Access Compliance Report

Public Rights-of-Way

(Curb Ramps)

Intersection ID: 7779	Main Street: FRIENDLY_PL	Cross Street: MARCUS_CT	Location:	E
ADA ID: 5541381822D8	Ramp Type: BlendTrans2	Initial Pass/Fail: Fail	Overall Compliance: No	Severity Score: 8.75

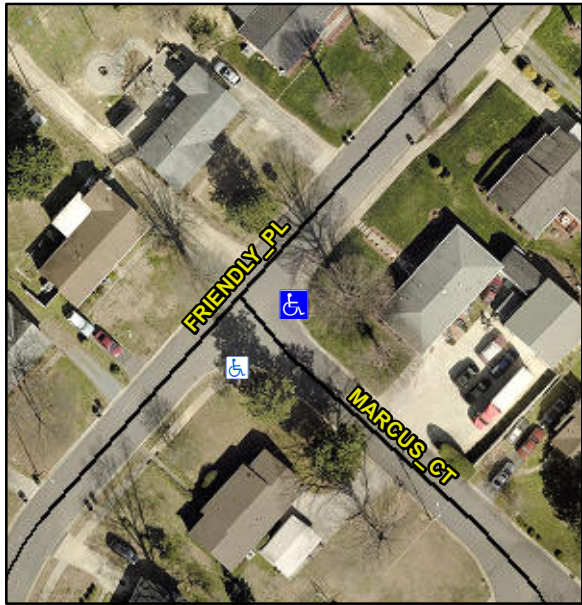
Codes/Mitigation Info/Possible Solution			Field Measurements/Component Compliance					
 Street 1 Name MARCUS CT Stop Condition-Street 1 StopSign Street 2 Name N/A Stop Condition-Street 2 N/A	Possible Solutions:		Compliance	Description	Data	Compliance	Description	Data
	Remove & Replace Curb Ramp With Two New Directional Ramps or Equivalent.		N/A	Ramp Length (in)	60.0	Yes	BlendTrans Slope (%)	4.1
			No	Ramp Width (in)	43.0	Yes	BlendTrans XSlope (%)	0.8
			N/A	Flare Type LT	N/A	N/A	Flare Type RT	N/A
			N/A	Flare Slope LT (%)	N/A	N/A	Flare Slope RT (%)	N/A
			N/A	Flare Traversable LT?	N/A	N/A	Flare Traversable RT?	N/A
			N/A	Landing Length (in)	N/A	N/A	DWS Provided?	N/A
			N/A	Landing Width (in)	N/A	N/A	DWS Contrast?	N/A
			N/A	Landing Slope (%)	N/A	N/A	DWS Length (in)	N/A
			N/A	Landing X Slope (%)	N/A	N/A	DWS Full Width?	N/A
Surveyor Notes: N/A			N/A	Landing Curb? (Y/N)	N/A	N/A	DWS Offset (in)	N/A
			N/A	Shared Landing?	N/A

N/A	Gutter Ponding?	N/A	N/A	Gutter Slope (%)	N/A
			N/A	Gutter Lip Ht (in)	1.0	N/A	Gutter X Slope (%)	N/A
			N/A	Painted X Walk1?	No	N/A	Painted X Walk2?	N/A
				X Walk 1 Direction	To SW		X Walk 2 Direction	N/A
				X Walk 1 Width (in)	N/A		X Walk 2 Width (in)	N/A
				X Walk 1 Slope (%)	2.0		X Walk 2 Slope (%)	N/A
				X Walk 1 X Slope (%)	3.1		X Walk 2 X Slope (%)	N/A
			N/A	Ramp inside XWalk1?	N/A	N/A	Ramp inside XWalk2?	N/A
PROW/ADA: Not Found, R304.5.1				Road Slope (%)	3.1		Clear Space?	N/A
				Road X Slope (%)	2.0	N/A	Clear Space to XWalk (in)	N/A
			N/A	Any Obstructions?	N/A	N/A	Storm Grate/Utility Hazard?	N/A
				Obstruction Type			Storm Grate/Utility Type	
					N/A			N/A
						Yes	Surface Condition? (G/P)	Good
						No	Curb Slope (%)	15.2
	Total Cost:		\$	3200.00
